<b>AMENDMENT OF SOLICITATION/MODIFICATION OF CONTRACT</b>		1. CONTRACT ID CODE	PAGE OF PAGES 1 10
2. AMENDMENT/MODIFICATION NO. 000001	3. EFFECTIVE DATE 06/20/2013	4. REQUISITION/PURCHASE REQ. NO.	5. PROJECT NO. (If applicable)
6. ISSUED BY NASA/Marshall Space Flight Center Office of Procurement Marshall Space Flight Center AL 35812	CODE MSFC	7. ADMINISTERED BY (If other than Item 6) NASA/Marshall Space Flight Center Marshall Space Flight Center AL 35812	CODE MSFC
8. NAME AND ADDRESS OF CONTRACTOR (No., street, county, State and ZIP Code)		(x) 9A. AMENDMENT OF SOLICITATION NO. NNM13ZPS004E	
		x 9B. DATED (SEE ITEM 11) 05/29/2013	
		10A. MODIFICATION OF CONTRACT/ORDER NO.	
		10B. DATED (SEE ITEM 13)	
CODE	FACILITY CODE

The purpose of this amendment to IFB NNM13ZPS004E, Revitalization and Repair of Central Chilled Water System for Building 4473, is to provide answers to questions asked by several of the potential bidders. These questions and answers are being provided to assist all contractors in preparing their bid.

MECHANICAL EQUIPMENT SCHEDULE  
REVITALIZATION/REPAIR OF CENTRAL  
CHILLED WATER SYSTEM (4473)

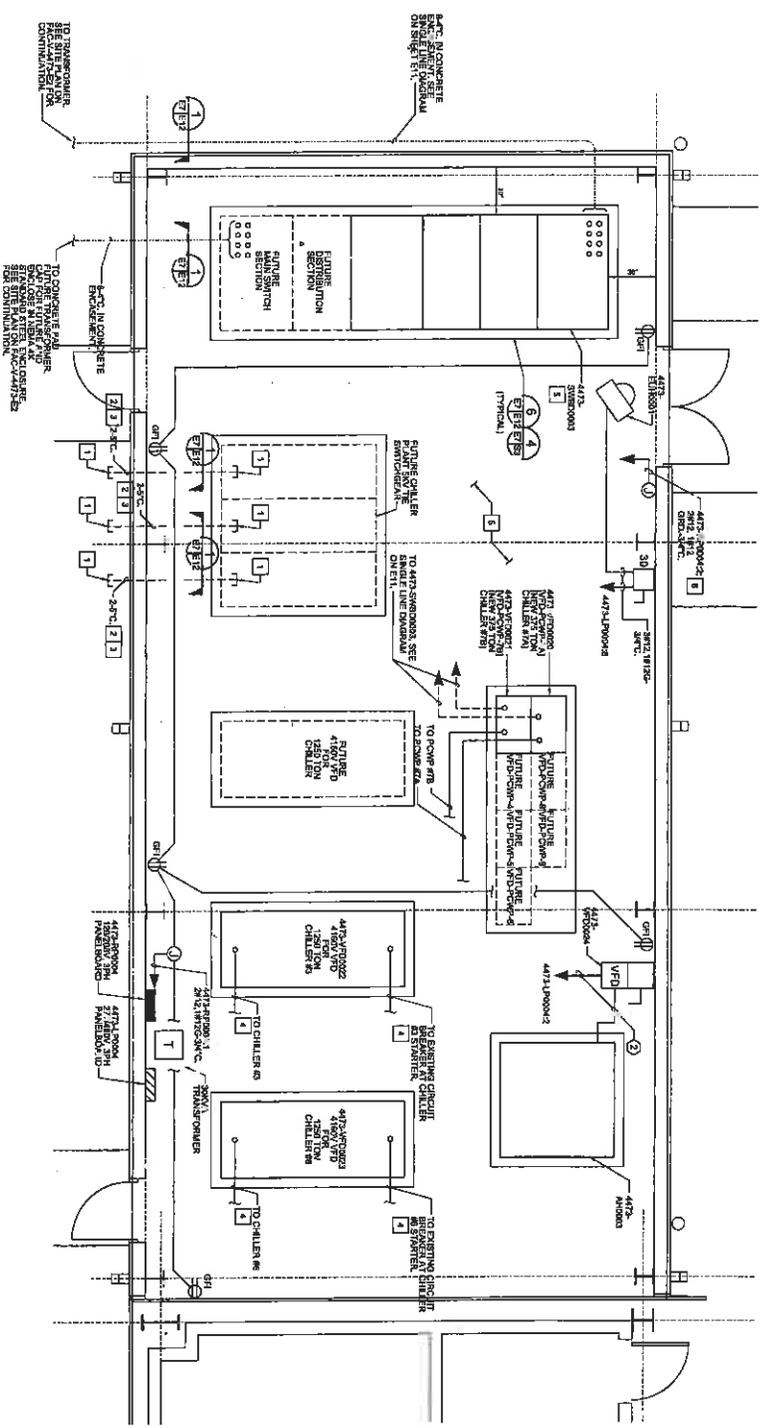
ITEM NO. (A)	SUPPLIES/SERVICES (B)	QUANTITY (C)	UNIT (D)	UNIT PRICE (E)	AMOUNT (F)
	<p>are required.</p> <p>Answer: Refrigerant cooled VFCs are acceptable, provided the refrigerant is R-134a or R-410a.</p> <p>Question 11: Please confirm if the 85dba requirement is sound POWER or sound PRESSURE level? We propose a sound PRESSURE level of 85dba per ARI-575 in lieu of the sound POWER level of 85dba for the 1250 ton chillers. The ARI standard is calculated in sound PRESSURE</p> <p>Answer: It should be sound PRESSURE level of 85 per ARI-575.</p> <p>Question 12: 2.12/B ( factory testing ) Can you clarify how many load points are to be tested? EXAMPLE ( 100%, 75%, 50%, 25%). Are all ten chillers are to be tested or just one of each tonnage size since they are identical?</p> <p>Answer: Four load points (part load verification). Refer to the ARI standards (550/590) in the specifications for part load testing procedures. Only one chiller from each configuration (1250 constant, 1250 VFD, 350 VFD) needs to be tested.</p> <p>SPEC SECTION 26 29 23 - Variable Frequency Controllers (Questions 13-15)</p> <p>Question 13: 26 29 23 VFC/ 2.1/A/2 ( 1250T VFC ) Is it acceptable to use a current source VFC in lieu of the IGBT type specified?</p> <p>Answer: No.</p> <p>Question 14: Chiller schedule electrical data MARK 4473-CHLR001, 2, 4 &amp; 5; 4473-CHLR003 &amp; 6; 4473-CHLR008 &amp; 9 The electrical data shows these chillers as 460/3/60. Please clarify if these chillers are to be 460/3/60 or 4160/3/60 voltage.</p> <p>Answer: This is a duplicate question, see the response to a previous question.</p> <p>Question 15: Chiller schedule (4473-CHLR007A and 7B) Can you confirm the full load and NPLV kw per ton are correct for the MCA shown? The MCA Continued ...</p>

ITEM NO. (A)	SUPPLIES/SERVICES (B)	QUANTITY (C)	UNIT (D)	UNIT PRICE (E)	AMOUNT (F)
	<p>does not seem to match the efficiency level shown.</p> <p>Answer: The chiller schedule is correct.</p> <p>Question 16: This specification calls for steel pipe and copper pipe materials for the hydronic piping systems. Would the government consider allowing Climatherm polypropylene piping manufactured by Aquatherm to be used for these hydronic systems? A submittal package is included for your review.</p> <p>Answer: Bid per plans and specifications.</p> <p>Question 17: Could we get contact information for the DDC Controls contractor who have the existing controls system for this building (name, phone number, etc.)?</p> <p>Answer: Dorsett Technologies, 100 Woodlyn Dr., Yadkinville, NC 27055. Lee Finney is the Dorsett Technologies representative for MSFC. Direct line: 336-679-2126 ext. 217; Toll Free: 800-331-7605; Fax: 336-679-8811.</p> <p>Question 18: Dwg E-11 show chillers 1, 2, 3, 4, 5, 6, 8 &amp; 9 being 4160V. Dwg M-16 show the same chillers being 480V.</p> <p>Answer: This is a duplicate question, see response to a previous question.</p> <p>Question 19: The (2) 5" conduits leaving existing 4160V gear to new 1000kva transformer on interior of building, should they be RGS or is EMT ok per specifications?</p> <p>Answer: EMT is acceptable interior to the building</p> <p>Question 20: Dwg E-2 (B5). The existing communication duct bank. Does the duct bank remain under new building?</p> <p>Answer: Yes.</p> <p>Question 21: Dwg E-7. There are note tags to nothing, is there a "cad layer" turned off?</p> <p>Answer: A printing issue was identified in the files provided on the bid disk. The attached Continued ...</p>
